Written Statement to the National Capital Planning Commission for 7/9/26 Meeting

Re: New Monumental Arch Project, NCPC File Number: 8778

National Capital Planning Commission (File Number 8778)

**Public Testimony of Rob Nieweg
Senior Vice President of the National Trust for Historic Preservation
Before the National Capital Planning Commission
Regarding the New Monumental Arch Proposal**

Section 75 Viewshed Looking Northeast – What is the Arch Impact Here?

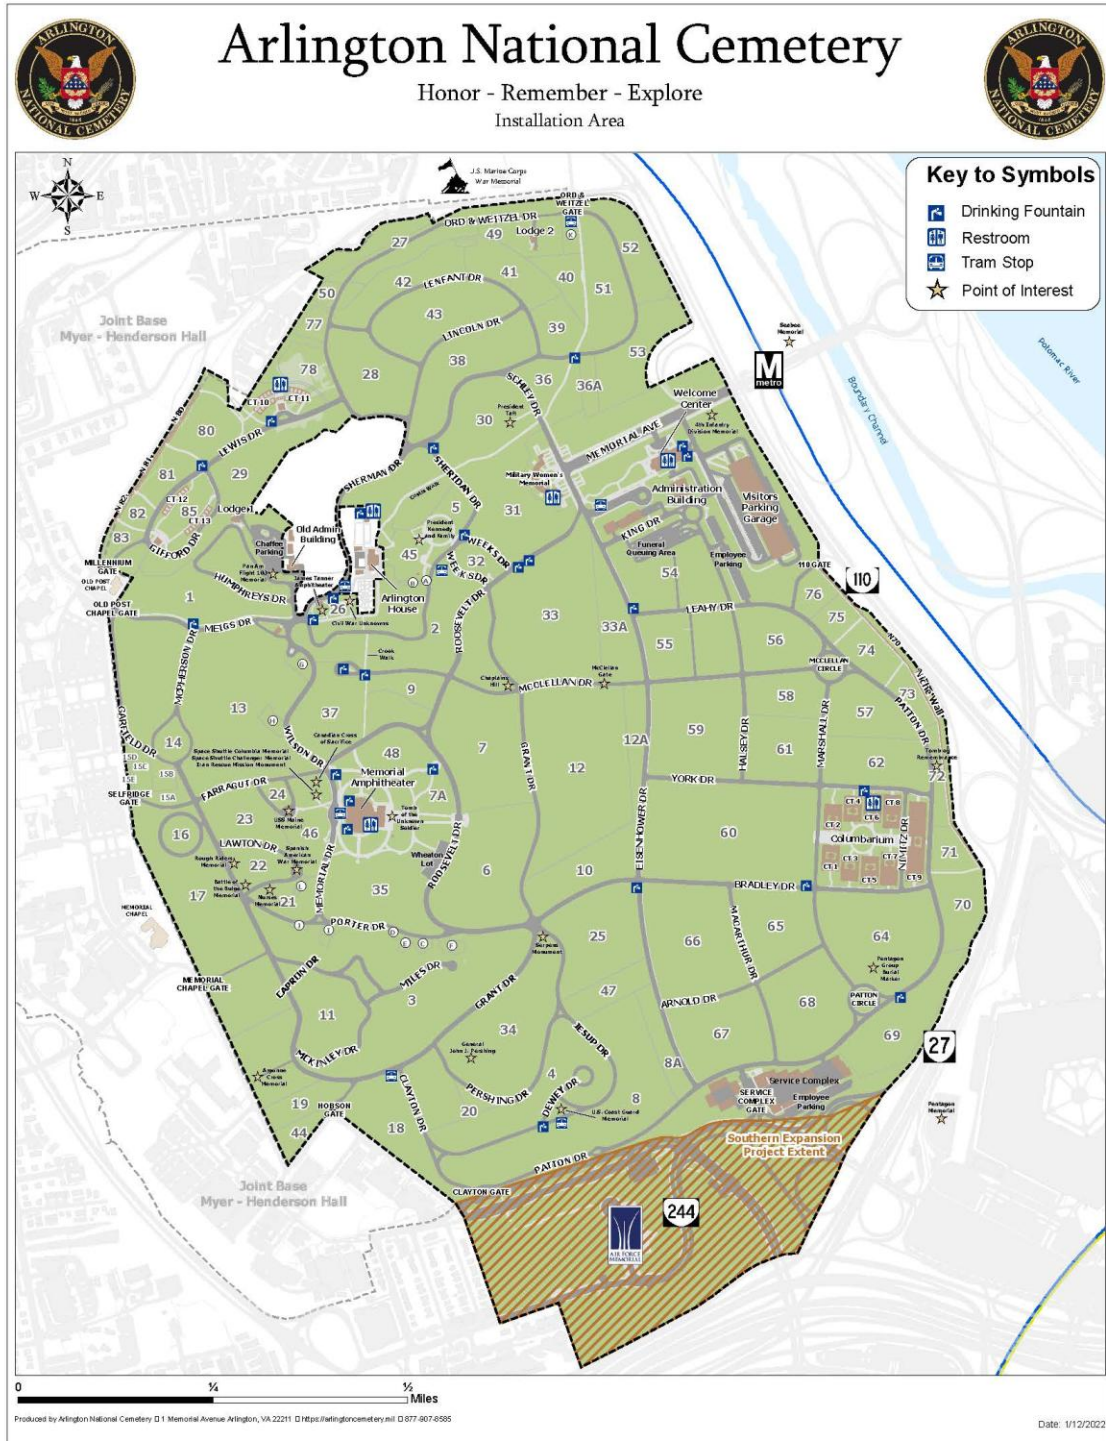
This photo was taken on May 31, 2026, overlooking Section 75 in the Northeast direction. There is no equivalent rendering in the project documentation. The Niche Wall containing cremated remains can be seen along the tree line at the boundary of the Cemetery. The Washington Cathedral and Rosslyn are visible in the far background. The top of the Lincoln Memorial is barely visible between some of the treetops. Without professional renderings, it is difficult to appreciate how much of the Arch will be in view from this location, with and without leaves on the trees. There are frequent funerals in this area, in fact many recent nearby graves, just out of frame of this photo, are currently awaiting installation of headstones.

Should this undertaking proceed, it is my strong belief that the Viewshed in this area will be severely impacted by the installation of a Triumphal Arch (even more so in Winter than this photo would suggest). To make matters worse, many of the recent graves in this area contain the remains of our Vietnam Veteran cohort, the vast majority of whom were drafted, and then returned to a country that did NOT appreciate their service (to say the least). Several of them have remarked about the fact that while they were drafted and served, our current President (and his family) did not.

Below: Primary Site #1, NCPC Memorials and Museums Master Plan Page 35

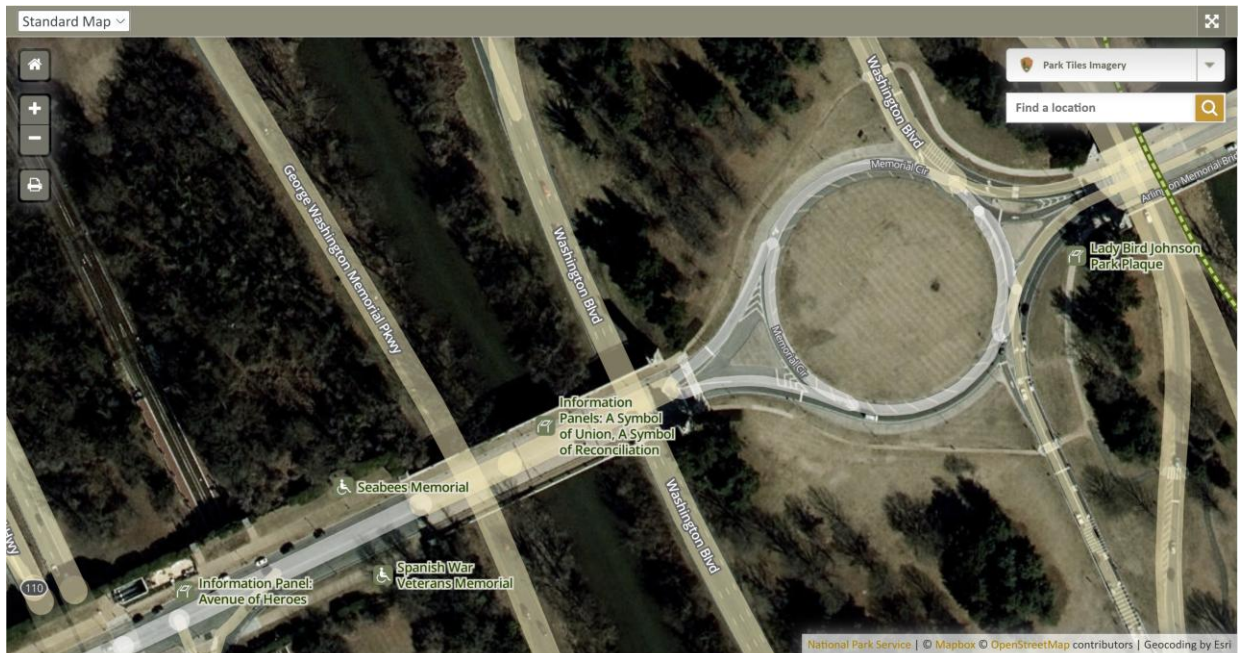
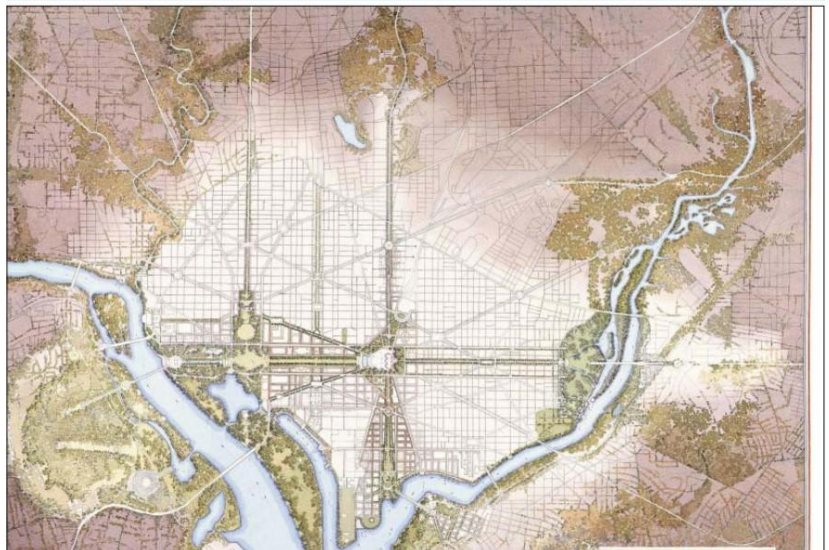
4. Even the NCPC’s own “Memorials and Museums Master Plan”² explicitly states: **“the existing circle at the west end of Memorial Bridge is not viewed as appropriate for the location of a future memorial.”** Instead, it identifies, as Prime Location #1, the area nearby the Spanish War Veterans Memorial.³ Not Memorial Circle.

A primary memorial site opportunity exists in association with Memorial Avenue. Although the existing circle at the west end of Memorial Bridge is not viewed as appropriate for the location of a future memorial, a major destination site opportunity exists to the west of the circle on the Virginia side of the channel.
